PDG Para	Issue	Compliance description	Compliance Conclusion
Section 1: Purpose of the guidance			
1~12	<b>Background</b>	-	OK
Section 2: Navigation			
13~19	<b>Background</b>	-	OK
<b>1- General requirement</b>			
20	On stretches influenced by hydropower developments, the terms of reference of all the hydropower developments shall refer to the same definitions of Highest Operating Level (HOL), Normal Operating Level (NOL), and Lowest Operating Level (LOL).	<p>1. Maximum navigable flow is the 3-years flood accounting for 17,800 m<sup>3</sup>/s</p> <p>2. The minimum navigable flow is 1,495 m<sup>3</sup>/s which correspond to a downstream water level of 199.62 m after the completion of the HPP and taking into account 1m of bed incision (220.62 m before). It is argued that the minimum water level is taken as the water level with 95% assurance rate which need to be checked on the H/Q to insure full compliance.</p>	OK

ATTACHMENT:

Fig.1 Operation Mode

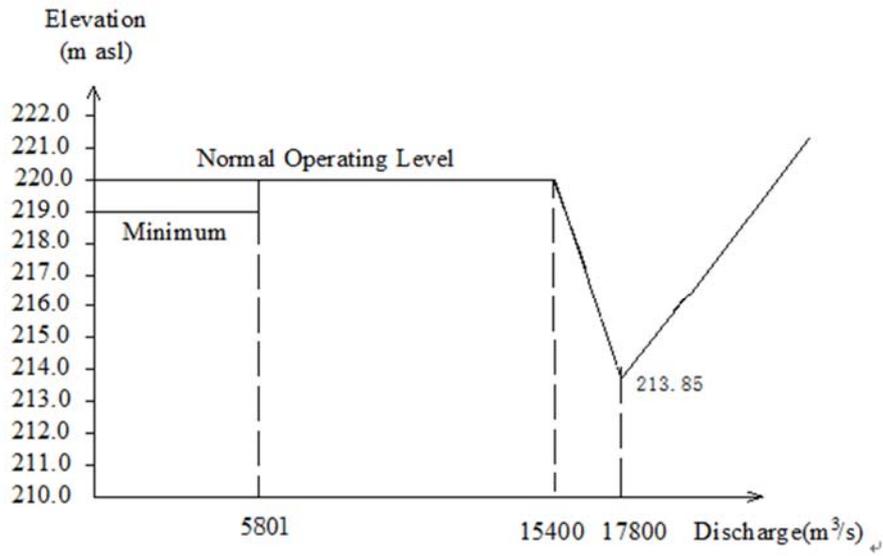
PDG Para	Issue	Compliance description	Compliance Conclusion
120	Developers should design mainstream dams to pass fine suspended sediment and coarse bed-load material in a way that most closely mimics the natural timing of sediment transport dynamics in the river.	<p>Designed as a power station in river channel, Sanakham HPP will generate power with the inflowing water and the reservoir has no regulation and storage capacity. Therefore, operating mode of the reservoir is proposed on the basis of the reservoir area condition and the water-sediment characteristics.</p> <p>Luang Prabang hydrometric station is taken as the key station for survey of inflow flood (generally the duration for flood running from the Luang Prabang hydrometric station to Sanakham dam site is 1~2 days). The peak flood discharge at Sanakham damsite in case of a 3-year flood occurred at Luang Prabang hydrometric station is 15400 m<sup>3</sup>/s.</p> <p>According to the sediment characteristics of Mekong River, the sediment volume is mainly concentrated in the wet season, especially when flood occurs, when the incoming flow is more than rated flow 5801 m<sup>3</sup>/s, bottom hole, sediment flushing gate and the flood gate opened gradually, reservoir water level maintains at 220m; when the discharge is greater than 15400 m<sup>3</sup>/s, gradually increase the gate opening and reduce the reservoir water level, If incoming flow is higher than the 3-year frequency flood discharge of 17,800m<sup>3</sup>/s, all gate should be opened, the flood passing and sediment discharging are basically approached to the natural channel, the sediment is prevented from depositing in the reservoir, and partial sediment in the reservoir will be carried away at the same time. According to Preliminary DG of LMB Mainstream Dams, water level shall be lowered to transport sand and flush partial sediment in the reservoir area according to the sediment monitoring after the power station putting into operation. Detail design is shown in the report of "SEDIMENT MANAGEMENT". Refer to Fig.1 in Attachment.</p>	OK

130	Seasonal drawdown of the reservoir to minimum operating levels and opening of gates to allow sediment pass-through should be carried out when sediment concentrations and sediment transport rates are high (e.g. passing of suspended sediment from the start of, or early in the flood season before larger flood flows to limit settlement in the reservoir).	Designed as a power station in river channel, Sanakham HPP will generate power with the inflowing water and the reservoir has no regulation and storage capacity. Therefore, operating mode of the reservoir is proposed on the basis of the reservoir area condition and the water-sediment characteristics. Luang Prabang hydrometric station is taken as the key station for survey of inflow flood (generally the duration for flood running from the Luang Prabang hydrometric station to Sanakham dam site is 1~2 days). The peak flood discharge at Sanakham damsite in case of a 3-year flood occurred at Luang	OK

PDG Para	Issue	Compliance description	Compliance Conclusion
		<p>Prabang hydrometric station is 15400 m<sup>3</sup>/s.</p> <p>According to the sediment characteristics of Mekong River, the sediment volume is mainly concentrated in the wet season, especially when flood occurs, when the incoming flow is more than rated flow 5801 m<sup>3</sup>/s, bottom hole, sediment flushing gate and the flood gate opened gradually, reservoir water level maintains at 220m; when the discharge is greater than 15400 m<sup>3</sup>/s, gradually increase the gate opening and reduce the reservoir water level, If incoming flow is higher than the 3-year frequency flood discharge of 17,800m<sup>3</sup>/s, all gate should be opened, the flood passing and sediment discharging are basically approached to the natural channel, the sediment is prevented from depositing in the reservoir, and partial sediment in the reservoir will be carried away at the same time.</p> <p>According to Preliminary DG of LMB Mainstream Dams, water level shall be lowered to transport sand and flush partial sediment in the reservoir area according to the sediment monitoring after the power station putting into operation. Detail design is shown in the report of "SEDIMENT MANAGEMENT". Refer to Fig.1 in Attachment.</p>
